## Received Comments on SP 800-131: Recommendation for the Transitioning of Cryptographic Algorithms and Key Sizes

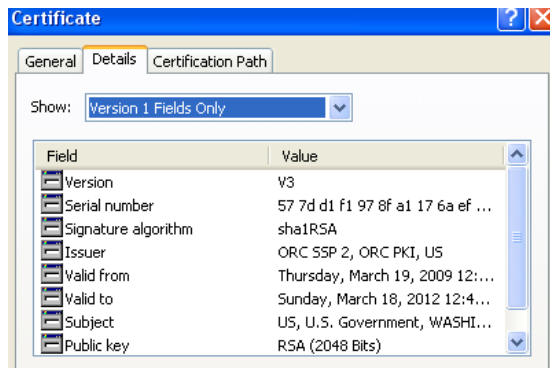
I have attached a document with screen shots of my smart card certificate. This was recently (fall of 2009) updated to allow use with OMB's "CyberScope" FISMA Reporting application.

According to your presentation (slide 6), the transition will make certain Digital Signatures invalid beginning 2011. It appears the Cert. (from the ORC service provider) on my card will be valid re: the requirement to use RSA  $\geq$  2048 bits and a signature verification  $\geq$  80 bits. However, the highlighted section which states invalidation of implementations of RSA that only use SHA-1 for Dig sig generation.

See arrows on the enclosed document. Of note is the thumbprint algorithm using "sha1" and the signature algorithm "sha1RSA." This would appear to fit into the invalidation criteria range. Could you or one of your coworkers validate that this is correct. If you need additional information let me know. Note these certificates are supposed to be "valid" until 3/18/2012.
